ץ Part Elevation of McLaren Wall

type of stone sample for approval.	Job Ref Dwg No P1154-RHP-ZZ-00-DR-A-5	Revision
F	Localised motar patch repair profiled and colour matched to	Scale(s) Size Drw Varies P1154 A1 TP	n Chkd PN
	existing. Provide sample for approval.	Status Preliminary	SO

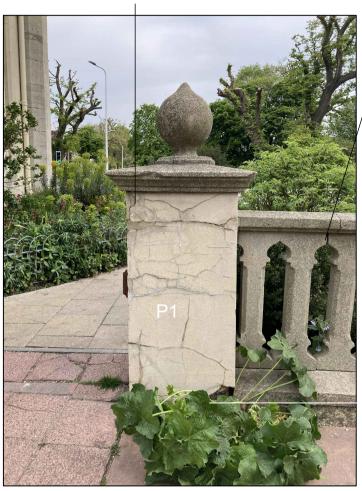
Existing Pier P1 to be carefully recorded, capstone removed and stored for re-use and taken down and re-built and re-fix capstone. New lime rendered finish.

Remove redundant gate keep. Do not reinstate.

Existing stone boundary wall has been vandalised and removed off site for storage (TBC). Image taken on 28.04.2022.

Existing stone boundary wall has been vandalized and removed off site for storage (TBC). CTP Image taken on 17.07.2023. Allow for repairs and reinstatement. Refer to SE details for SS rods resin fixed to existing plinth reinforcement.

Image of wall panel prior to vandalism. Image taken on 28.04.2022.

3 Part Elevation of McLaren Wall 5010 NTS

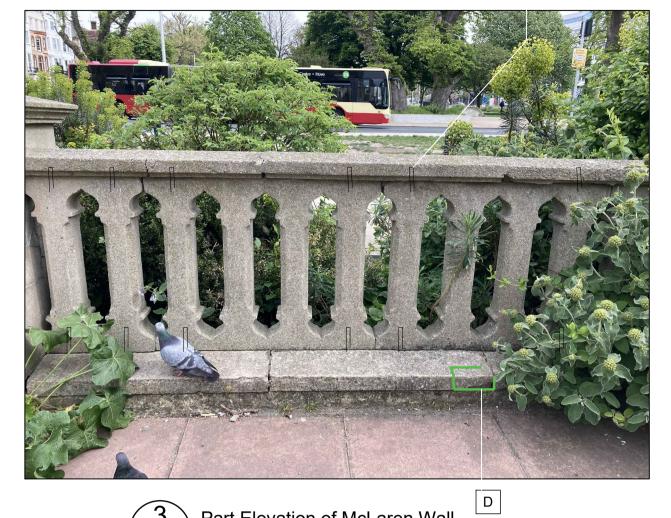
New 6 mm dia. SS threaded dowels lime grouted into balustrades and capping/ plinth to reinforce connection

Crack through whole capping. Resin and SS dowel repair.
